**Planning Department
Transportation Development Services**

**Re: Health Care for the Homeless, 1220 First Street NW
Traffic Circulation Layout**
Architect's Stamp dated 9-26-14 (J14-D172)

Based upon the information provided in your submittal received 10-10-14, the above referenced plan cannot be approved for Building Permit until the following comments are addressed:

TRAFFIC
CIRCULATION
LAYOUT

AS-001

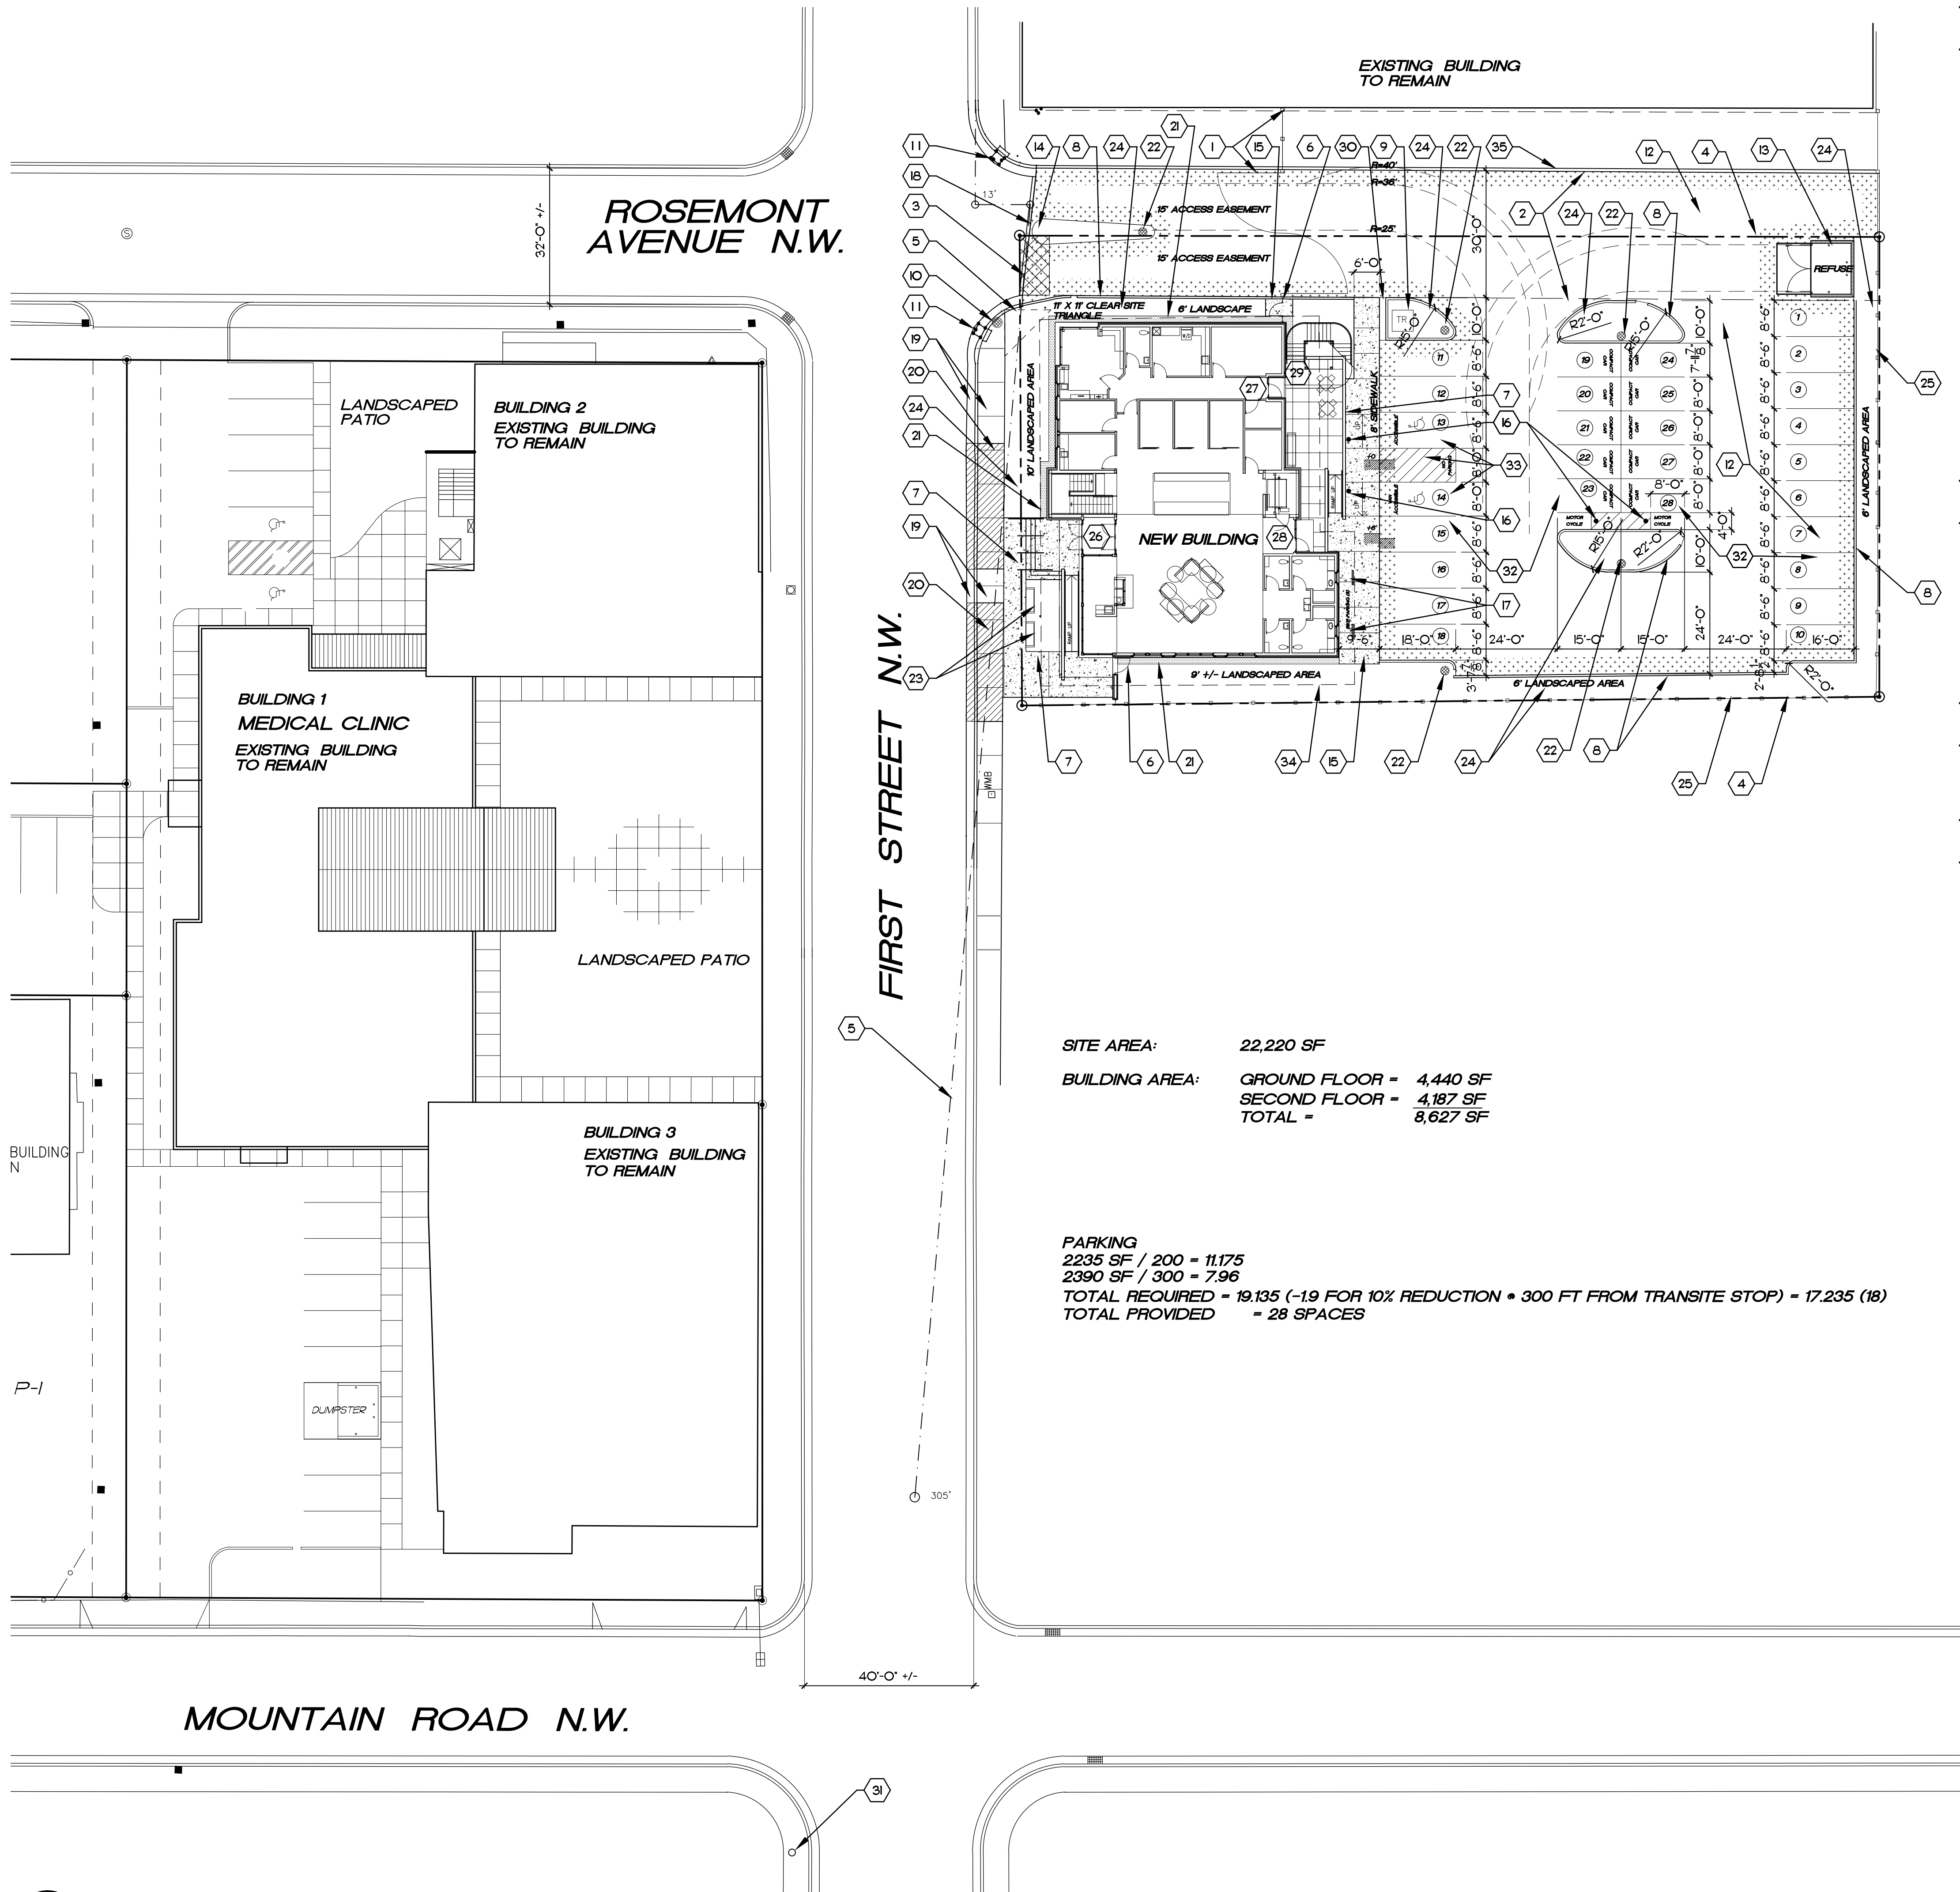
1. The total required number of parking spaces is listed as 18, but a total number of 28 is provided. Please clarify.
2. Identify the existing street widths for Rosemont Avenue and First Street. Label the 15-foot access easements as "Private 15-foot Access Easements".

3. The handicap accessible spaces must be a minimum of 8.5 feet in width. One is shown as only 8.0 feet wide.
4. The parking spaces on the east side of the lot are shown as 16 feet wide, and they need to be a minimum of 18 feet wide.

5. Provide signage detail as called out by Keyed Note 16 on the plan. The ADA van accessible sign must have the required language per 66-7-352.4C NMSA 1978 **"Violators Are Subject to a Fine and/or Towing."**

6. The words **"NO PARKING"** in the ADA access aisle shall be at least one foot high and at least two inches wide (66-1-4.1.B NMSA 1978). Designate this on the drawing.

7. List radii for all curb radii on entrance to access easements from First Street. Also, include curb radii information for the median. Wheelchair ramps must be provided for wheelchair access across the 30-foot access easement along with truncated domes. Show lane widths from the median curb to the outer curb.

8. The new PNM Pole called out on Keyed Note 10 needs to be a minimum of 18 inches behind the face of curb.

9. Provide a "Keep Right" sign on the median for traffic entering the access easement from First Street. Paint the median curb yellow.
10. A 6 foot-wide ADA accessible pedestrian pathway is required from the public sidewalk on First Street to the building entrances. Please widen the ramp up to the primary building front entrance to 6 feet wide.

11. A 6 foot-wide ADA accessible pedestrian pathway is required from the HC parking stall access aisles to the building entrances. Please widen the ramp from the parking lot up to the back door access to 6 feet wide.

12. Provide a 6-inch or 8-inch high concrete barrier curb between the parking lot and the 8-foot sidewalk on the east side of the new building.
13. The design delivery vehicle route needs to be shown.

14. It is not apparent what type of pavement surface is being proposed. A hard driving surface will be required as part of this proposed project for parking area and drive aisles. Show and label thickness of asphalt if providing an asphalt parking lot.

15. Please add the following note to the clear sight triangle: "Landscaping and signage will not interfere with clear sight requirements. Therefore, signs, walls, trees, and shrubbery between 3 and 8 feet tall (as measured from the gutter pan) will not be acceptable in this area."
